EMV® Terminal Type Approval Bulletin No. 255
Second Edition November 2022

IFM Level 1 Renewal Process

This Bulletin updates the IFM Level 1 renewal testing in v4.3d

Therefore, the applicable Test Plan for Renewal testing is as follows:

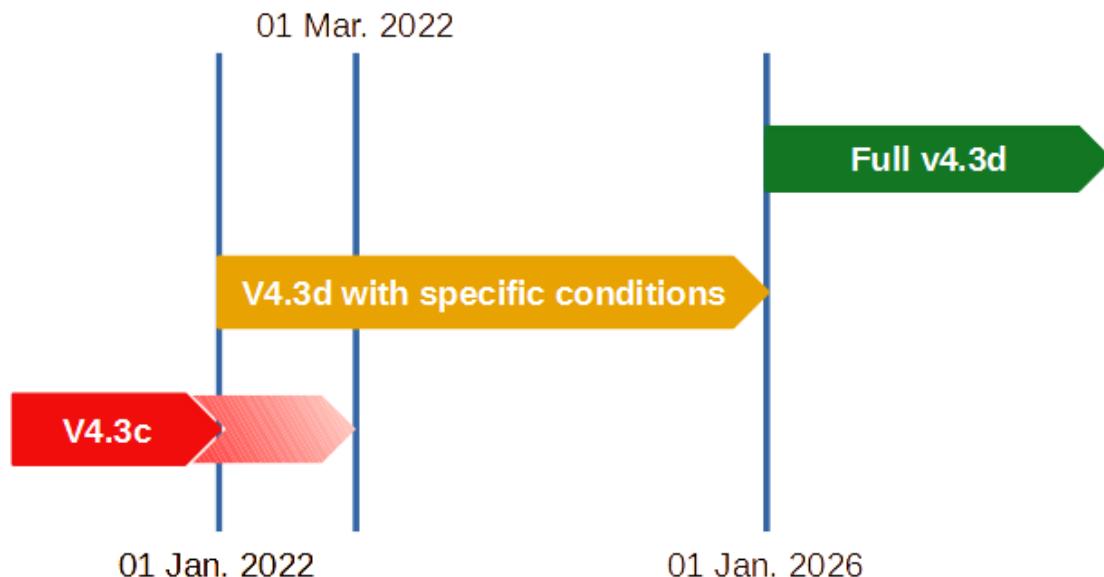
However, considering specific issues impacting the transition between versions 4.3c and 4.3d, EMVCo defined an intermediate period during which v4.3d Renewal testing will be applicable with specific conditions (See below for further details).

Starting from January 1st 2026, the v4.3d test plan will be fully applied for renewal.

These conditions are applicable **only between January 2022 and end December 2025**.
